UNITED STATES ENVIRONMENTAL PROTECTION AGENCY

Re: *Conditional Approval of Revised Corrective Measure Proposal*
Tecumseh Products Company, 100 East Patterson, Tecumseh, Michigan 49286
EPA ID#: MID005049440
AOC RCRA-05-2010-0012

The US EPA has completed a review of the *Revised Corrective Measures Proposal* (CMP), dated March 6, 2017 that TRC prepared on behalf of Tecumseh Products Company (TPC). Based on that review and follow-up discussions with TPC, and in consultation with the MDEQ's Remediation Advisory Team, US EPA conditionally approves the CMP.

feet
meters

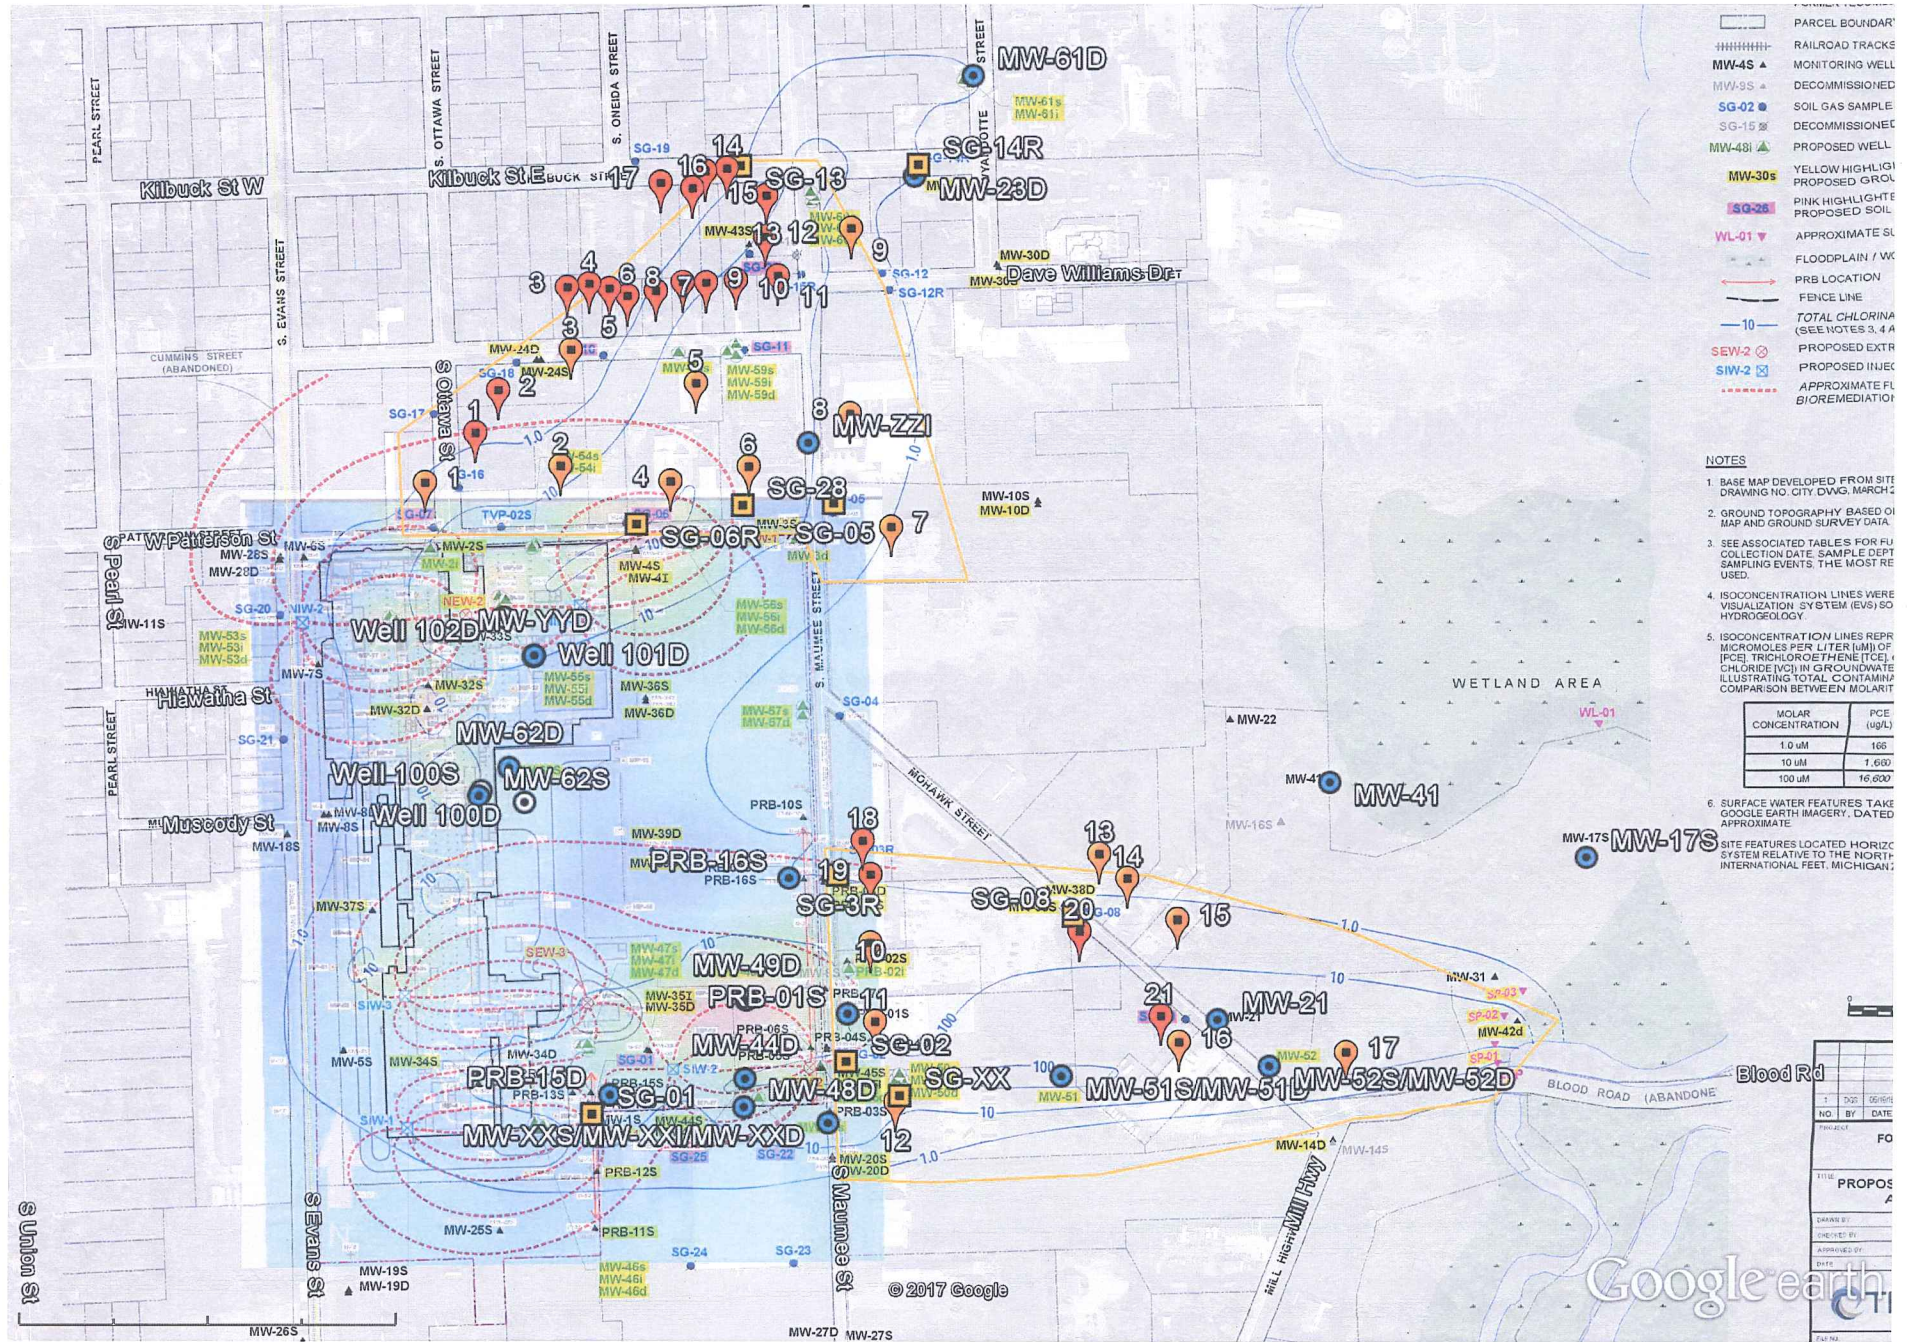
After reviewing the modifications in the revised 3/6/17 CMP, your proposed locations for groundwater monitoring are much closer to what I had envisioned. In addition to those locations proposed in the 3/6/2017 CMP, EPA requests the inclusion of performance groundwater monitoring at existing wells PRB-01S, PRB-15D, PRB-16S, MW-17S, MW-21, and MW-41, and has identified the need for monitoring at additional depths at locations proposed in the 3/6/2017 CMP to include MW-44D, MW-48D, MW-49D, MW-51 (include both shallow and deep intervals), MW-52 (include both shallow and deep intervals), MW-61D, MW-62 (include both shallow and deep intervals closer to source), MW-XX (shallow, intermediate and deep intervals at SB-80), MW-YY (deep interval, source areas south of MW-33S, installed east of source), and MW-ZZI (intermediate depth along Maumee, between Cummins and Patterson. These are shown on the attached Modifications.kmz file, compared with the locations proposed in the 3/6/16 CMP (New Proposed Monitoring.kmz).

In addition to those locations proposed in the 3/6/2017 CMP, EPA requests the inclusion of performance soil gas monitoring at existing locations SG-01, SG-02, SG-03R, SG-05, SG-08, SG-13, SG-14R, SG-28. EPA proposes the installation of a new soil gas location (or collocated vapor pin/indoor air location) at SG-XX, at the property where MW-50 is proposed. EPA also requests the potential reinstallation of SG-06R, given that the soil gas results appear inconsistent with groundwater data from this area, to determine if the existing location is isolated from subsurface contamination by a subsurface anomaly.
